AGENDA
CITY OF THE DALLES PLANNING COMMISSION
CITY HALL COUNCIL CHAMBERS
313 COURT SREET
THE DALLES, OREGON 97058
CONDUCTED IN A HANDICAP ACCESSIBLE MEETING ROOM
THURSDAY, JUNE 4, 2015
6:00 PM

STAFF REPORT

Conditional Use Permit 175-15

Defiance Brewery

Defiance Brewing Co.
5/22/2015

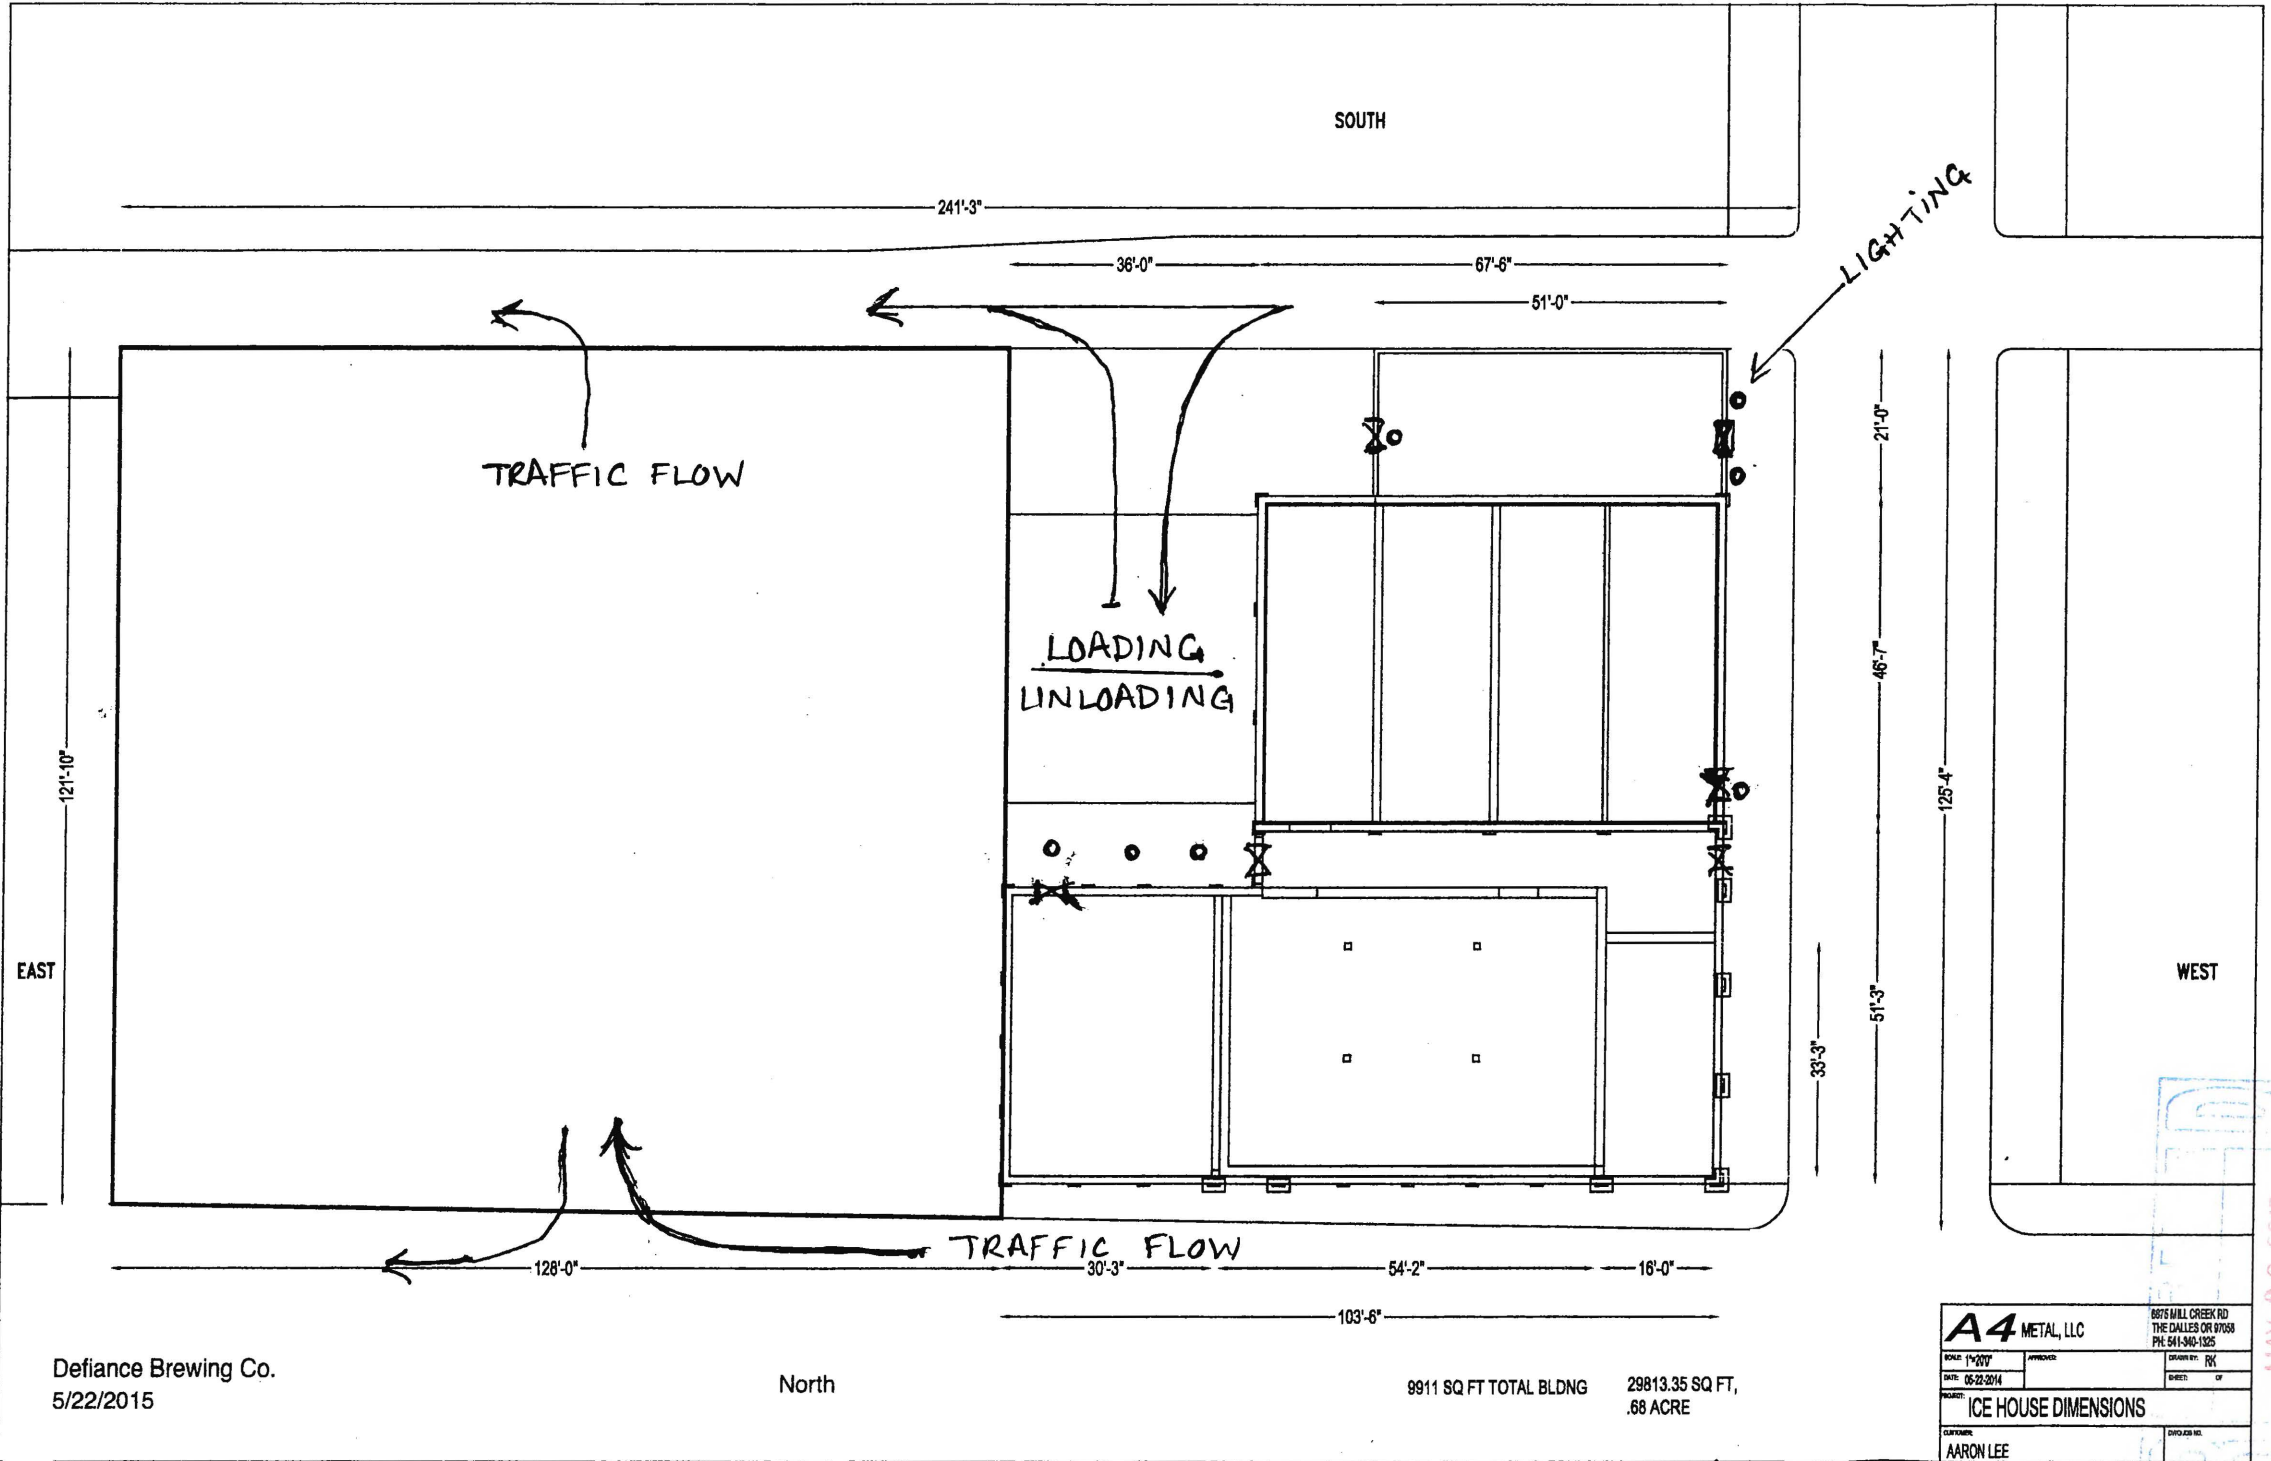
The applicant has provided drawings that show the truck/vehicle maneuvering area. Unfortunately, the existing configuration of the loading dock may force some maneuvering or backing onto the alleyway. Without a complete reconfiguration of the loading dock, the alleyway will be used for maneuvering. Maneuvering in the alleyway could pose an issue to adjacent businesses that use the alleyway for access. General Ordinance 86-1078 addresses this concern and requires that there is no blocking of the alleyway, however, it allows for expeditious loading/unloading for period to not exceed 30 minutes in any one hour period. Staff will suggest that this be addressed as a condition of approval.

FINDING A-29: The applicant has indicated on the site plan the location of the refuse collection. Details of the trash enclosure will be required to be provided to the planning staff. The screening will need to meet the requirements as stated above. Criterion will be addressed as a condition of approval.

8. All materials and supplies must be stored within the structure. No outside storage of business materials or supplies will be allowed.
9. Details of the trash enclosure will be required to be provided to the planning staff and is required to meet the screening standards as set forth in the ordinance.
